SUBJECT Alternative connection of M1 power supply

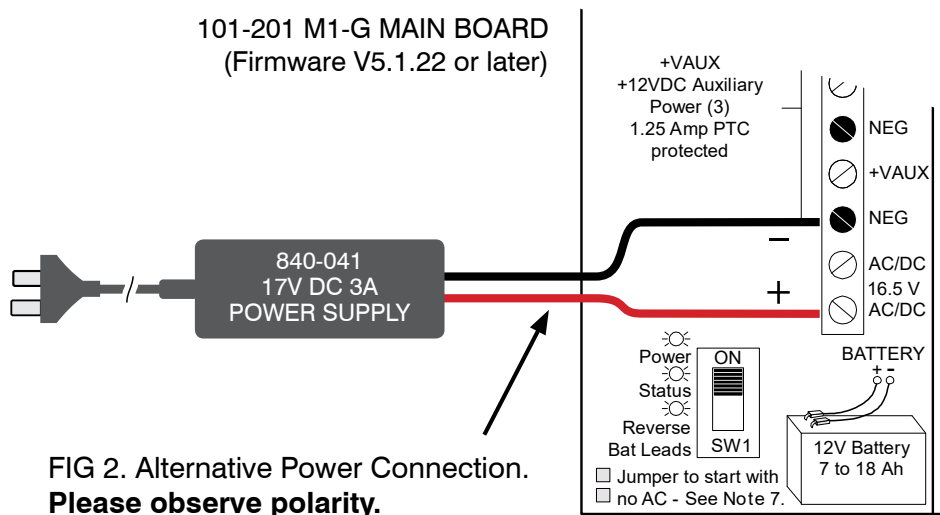
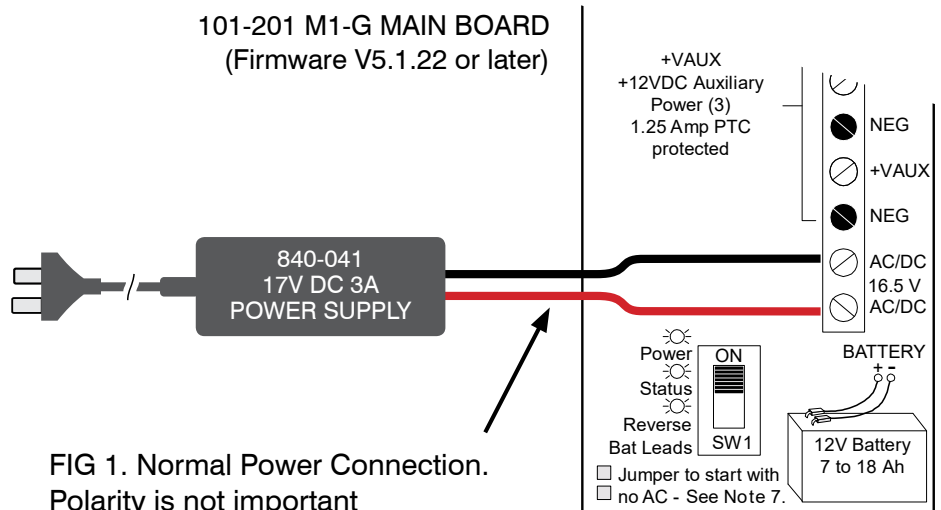
DETAIL In cases where an M1-G main board fails to power up normally, the **17VDC** power supply can be connected as shown in Fig 2. (power supply negative to AUX NEG)

Note. An M1 board failing to power up may be caused by normal variations in component tolerances in the power supply or the M1 board. Connecting the power supply as per Fig 2. will remedy the issue in most cases.
